# UNITED STATES PATENT AND TRADEMARK OFFICE

## Office Action Summary

10/523,780

## **SUPPLEMENTAL ACTION**

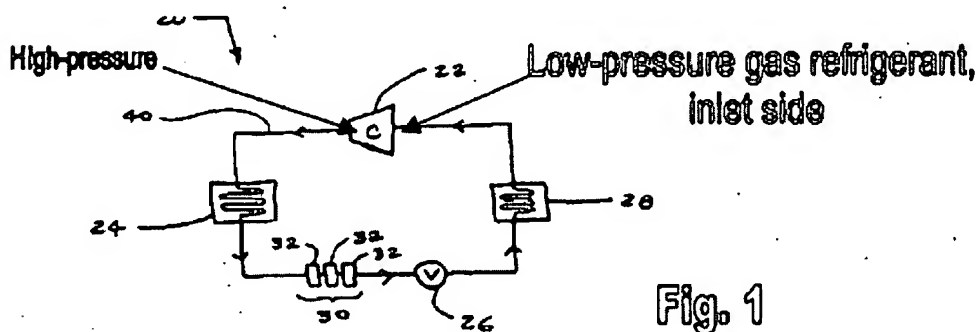
Sami et al. disclose the invention substantially as claimed including a plurality of utilization units (24, 28), a vapor compression type refrigeration circuit (20; col. 2, lines 53-63); including a high pressure unit (22, 24, 26 and reversing valve - col.8, lines 62-64) with high pressure refrigerant (col. 3, lines 7-21; it is understood that the refrigerant with working fluid temperature at the condenser between 20C to 90C characterized by being high-pressure refrigerants such as R410A) and a low pressure unit (Sami et al. low pressure unit consists of: a suction accumulator(col. 2, line 59), a reversing valve and an inlet side of the compressor 22) with a low pressure refrigerant (col. 7, lines 7-21; it is understood that the refrigerant with working fluid temperature at the evaporator between - 85C to 25C characterized by being low pressure refrigerants such as R410A), and a suction accumulator (col. 3, line 59) configured and arranged for pooling refrigerant that circulates inside said vapor compression type refrigerant circuit

(configured in suction/from low pressure side); and said refrigerant is azeotropic refrigerant such as R410A or R32 (col. 3, lines 7-21) which has saturated pressure characteristics higher than R407C.

Sami et al. do not explicitly disclose the maximum and minimum working pressure but that is an established characteristic of this reference as shown in the Akira et al. JP 2002-162126 (Toshiba Carrier Corp.), see translated pages 3, paragraph [0005]. Akira et al. teach that R410A refrigerant has pressure as high as about 1.5 times among HFC refrigerants compared with R22 refrigerant.

Fig. 1a

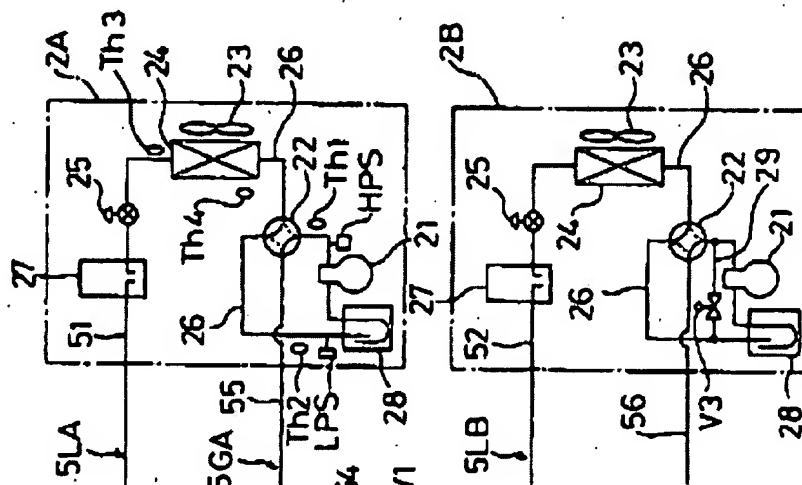
Sada teaches a plurality of utilization side (3A; 3B) heat exchangers (32) mutually connected (see lines 4L and 4G) in parallel (see Fig. 1) and arranged to operate as an evaporator (32); a switching mechanism (22) configured and arranged for switching between a state (Fig. 1); and a suction accumulator (col. 2, line 59) connected between said switching mechanism and the said inlet side of said compressor (see Fig. 1); said accumulator (28) connected between said switching mechanism and inlet side of said compressor (Fig. 1, col. 12, lines 1-3), said accumulator (28) configured and arranged for pooling low-pressure refrigerant (LPS) as a liquid refrigerant, said switching mechanism and the inlet

side of the compressor forming a low pressure unit (as seen in the illustration of Fig.1a);

and the compressor, said heat source side heat exchanger, said plurality of utilization side heat exchangers, and said switching mechanism forming a high pressure unit (Fig. 1).
